Product Change Notification

Product Group: NLR/Wednesday September 30, 2026/PCN-NLR-013-2026-REV-0

Change to completely Pb-free NTC SMD

Pb-bearing NTC SMD

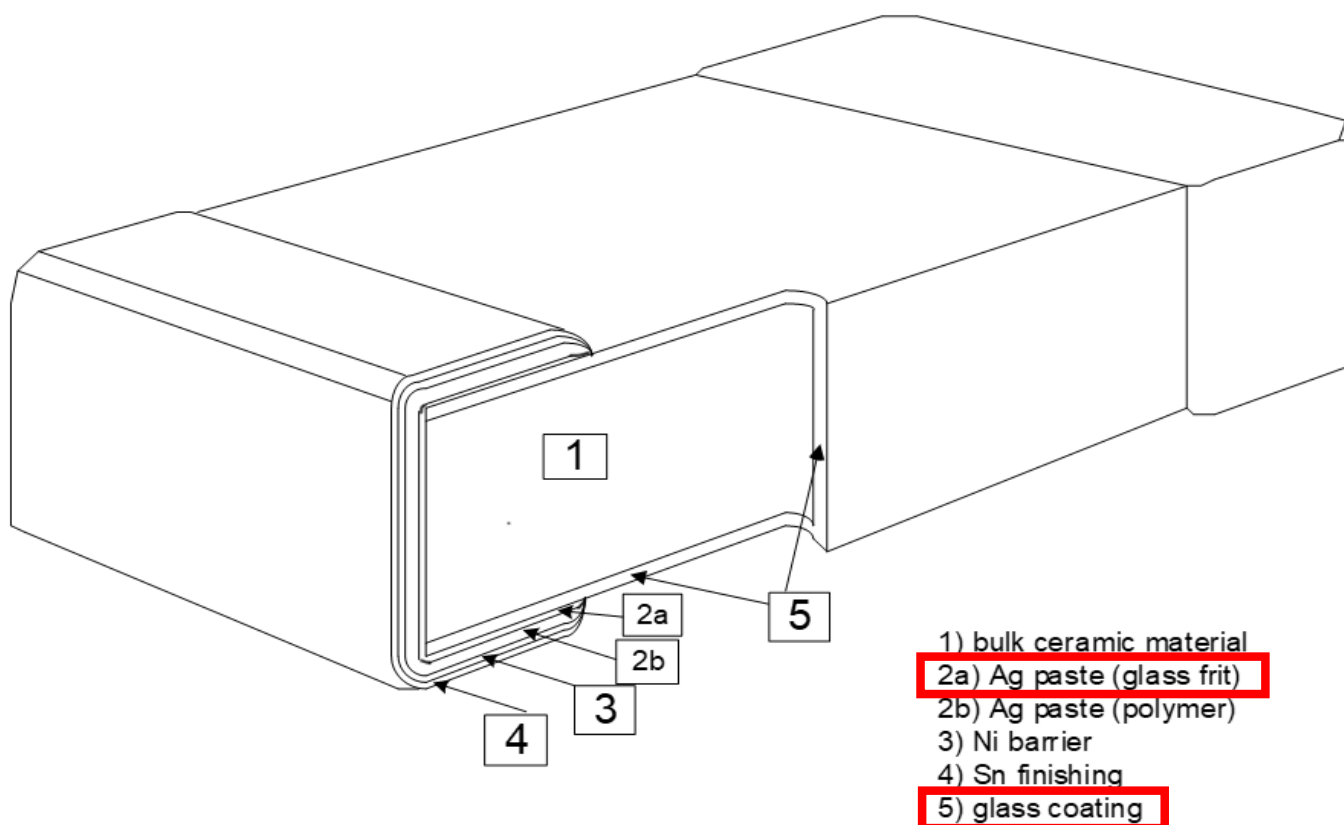
Part	Substance	Cas number	weight %
Glass cover (5)	Lead(2+)-silicate	10099-76-0	64%
	Glass without declarable substances	-	36%
Glass Ag Termination (2a)	Silver	7440-22-4	92%
	Lead(2+)-silicate	10099-76-0	5.8%
	Glass without declarable substances	-	2.2%

ROHS Compliant with exemption 7c-I
REACH compliant

Pb-free NTC SMD

Part	Substance	
Glass cover (5)	Glass without declarable substances	
Glass Ag Termination (2a)	Silver	
	Glass without declarable substances

Full ROHS Compliant (no exemptions)
REACH compliant
